SUBJECT: EDWIN I. HATCH NUCLEAR PLANT - NRC REACTIVE INSPECTION REPORT
05000321/2016009

Report No.: 05000321/2016009

Facility: Edwin I. Hatch Nuclear Plant

IR 05000321/2016009, April 4, 2016, through April 27, 2016; Edwin I. Hatch, Unit 1, Special Inspection to evaluate Hatch nuclear plant Unit 1 safety relief valve testing failures; Inspection Procedure 93812, "Special Inspection."

Figure 1 - BWR SRV (NRC Information Notice 2003-01, "Failure of Boiling Water Reactor Target Rock Main Steam Safety/Relief Valve," ADAMS ML030140543)

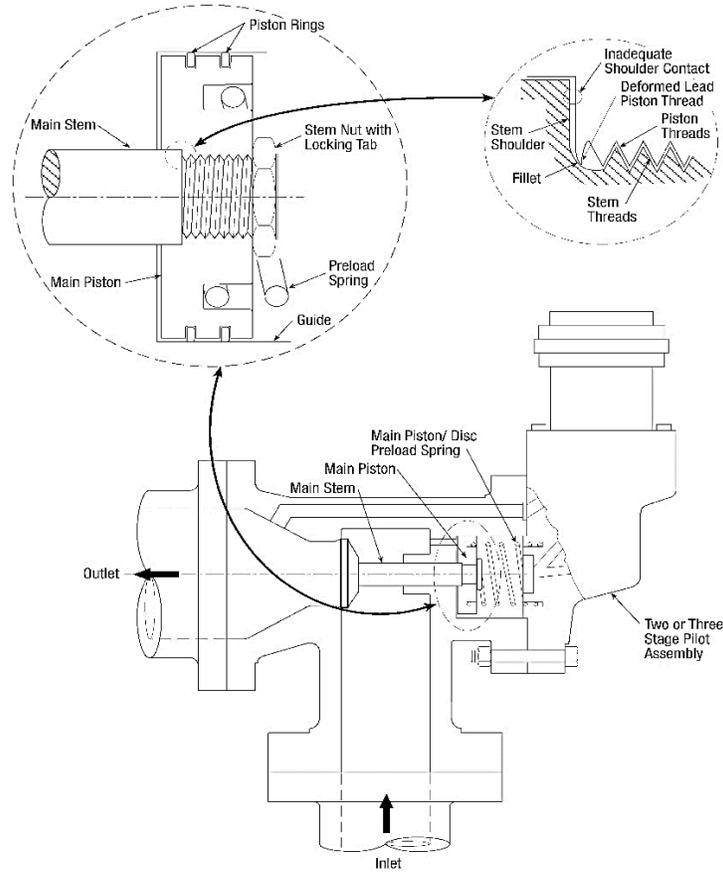
The team concluded that a degraded valve (shortened spring, de-shouldered stem-to-piston interface with attendant fretting and grooving of the main guide) may not fully re-close because the weakened spring does not contribute enough force to overcome the additional friction due to the piston rings sliding across the fretted grooves in the guide. This conclusion was supported when the team reviewed several test plots for the

affected valves which showed the position of the main disc/stem/piston assembly as a function of time. The team noted that the plots indicated that the assembly would proceed towards the closed position until the point where the lower piston ring encountered the first groove in the guide (worn by the upper piston ring) and then stall. The team determined that a valve in good operating condition should normally close on the test stand with only spring force to assist it.

The team noted that the test methodology could cause de-shouldering on the valve's open stroke which is the predecessor to the subsequent fretting damage (at the stem-to-piston interface and the piston-to-guide interface) in a plant vibration environment. Target Rock determined the root cause of the Pilgrim main guide fretting (due to piston/ring wear) resulted from excessive impact load during limited flow testing which relieved the torque applied to the piston-to-stem interface leading to the creation of a significant clearance between the piston and the main disc (de-shouldering) as well as plastic deformation of the piston-to-stem threads. This loss of shoulder-to-shoulder contact allows relative motion between the main piston and main disc. If the excessive
